**FILE:** X020922.016 **DATE:** 14 May 2021

**SUBJECT:** Information Relevant To Item 7.7 – Project Scope - Pitt Street North Walking and Cycling Improvements

**Attachment A.** Sketch of Eastern Side Cycleway Configuration

## Location 05: Bridge Street

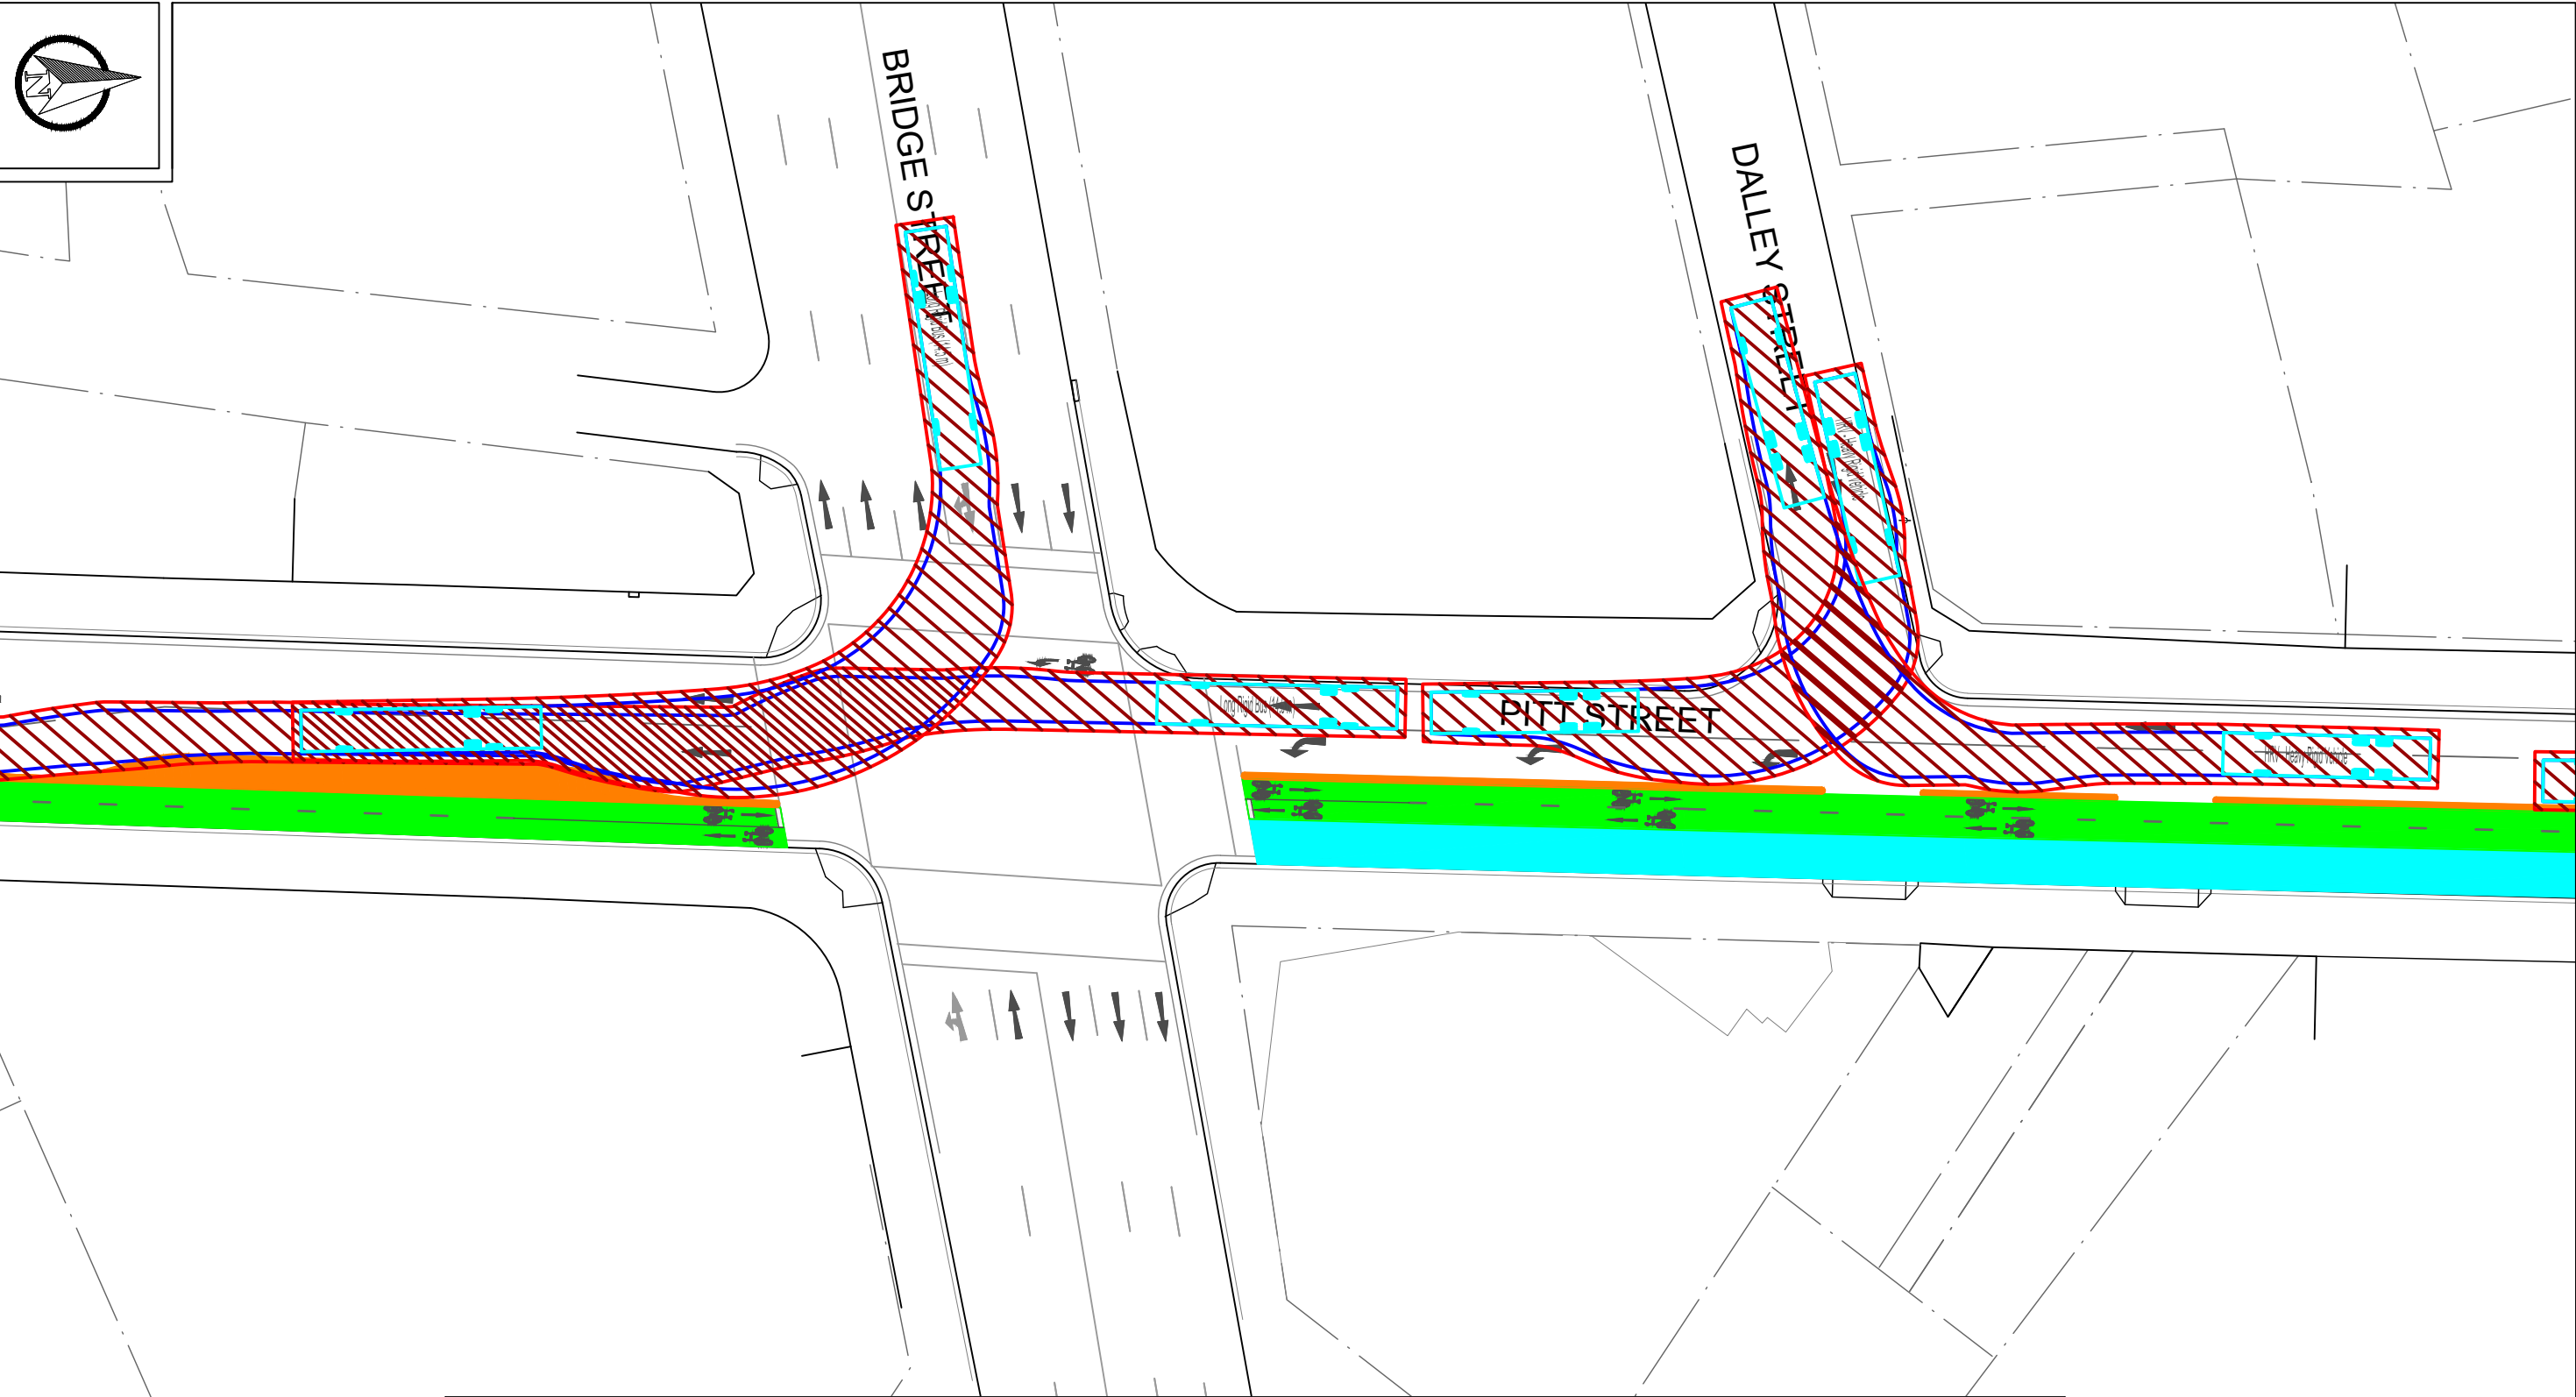
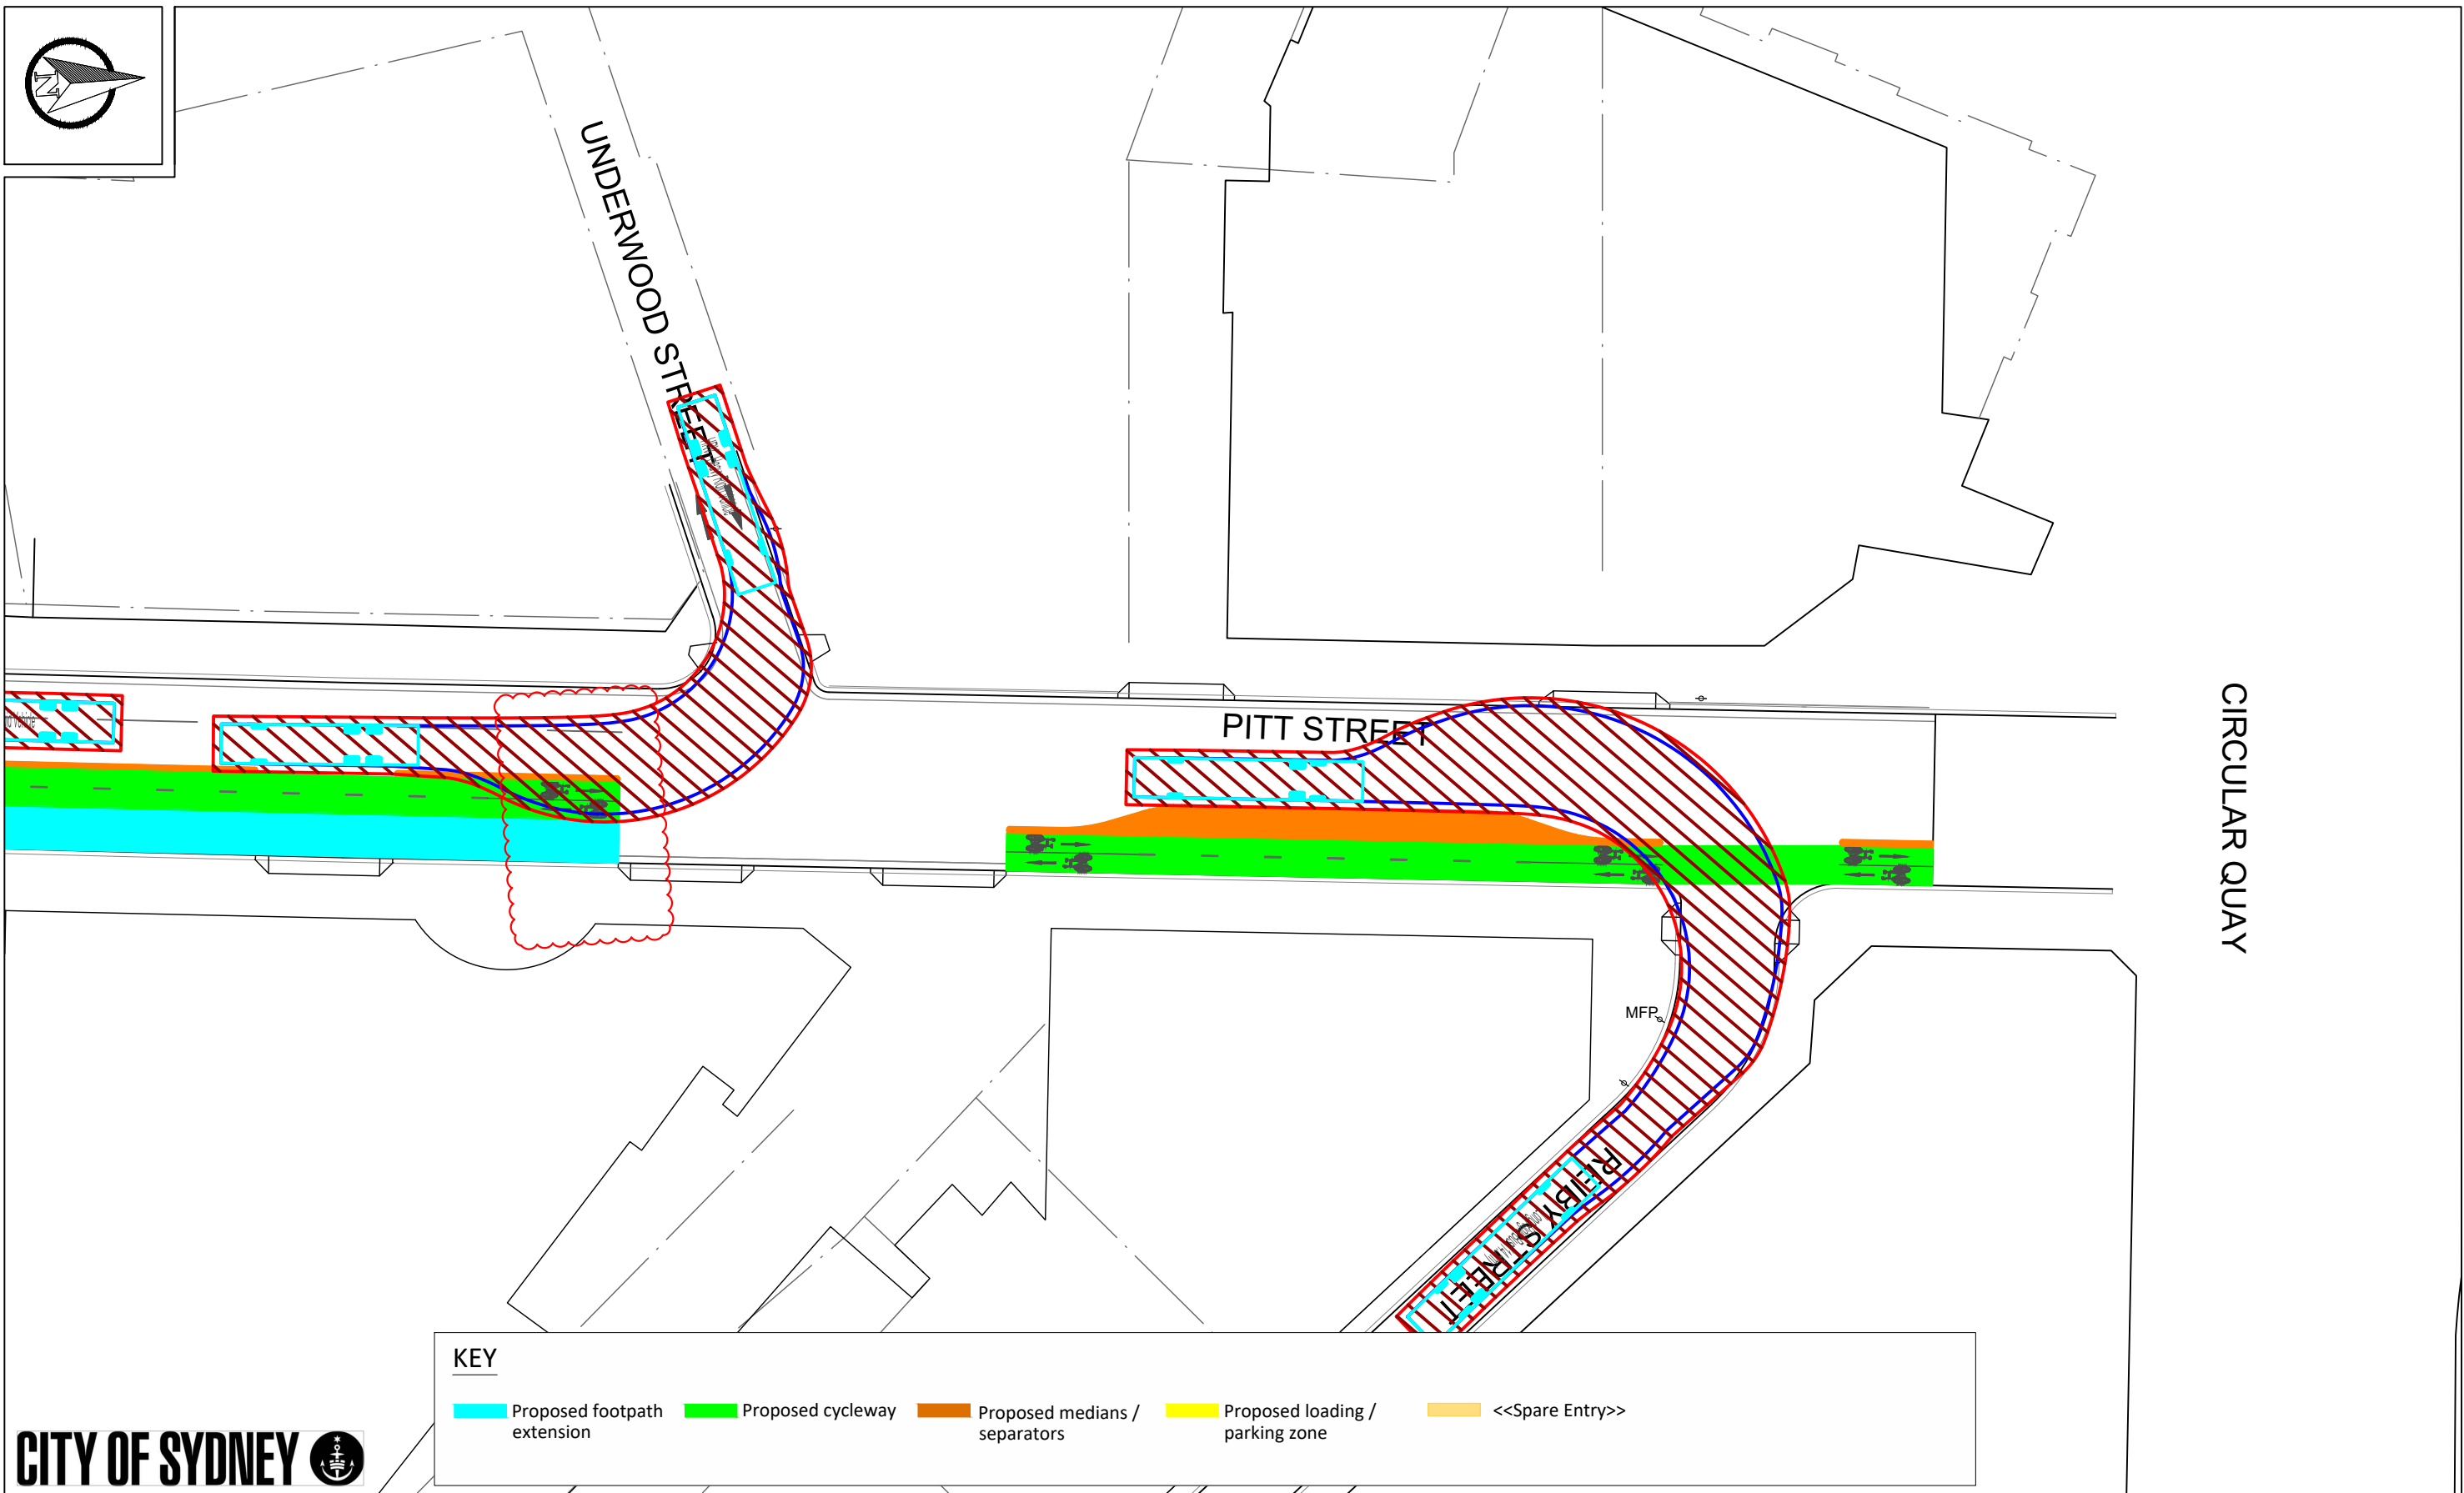
The Urbis submission requests the cycleway be moved to the eastern side of Pitt Street. Their primary contention is that the commercial car park driveways present a safety hazard to people riding when drivers exiting/entering car parks fail to look for bicycle riders. They also raised the following issues: cars queueing across the cycleway, misuse of the cycleway, pedestrian safety, delays in delivery times for businesses, unattractive materials, pedestrians crossing near Bond Street, and lack of bicycle parking.

The City has quickly prepared sketches of a configuration of the road space with an eastern side cycleway. This includes relocating the extra pedestrian area from the western side to the eastern side, and moving the parking on the eastern side to the western side (see Attachment A).

City staff, after reviewing the options again, recommend the cycleway should stay on the western side for road safety and efficiency of transport movement, as recommended in the original report to Committee.
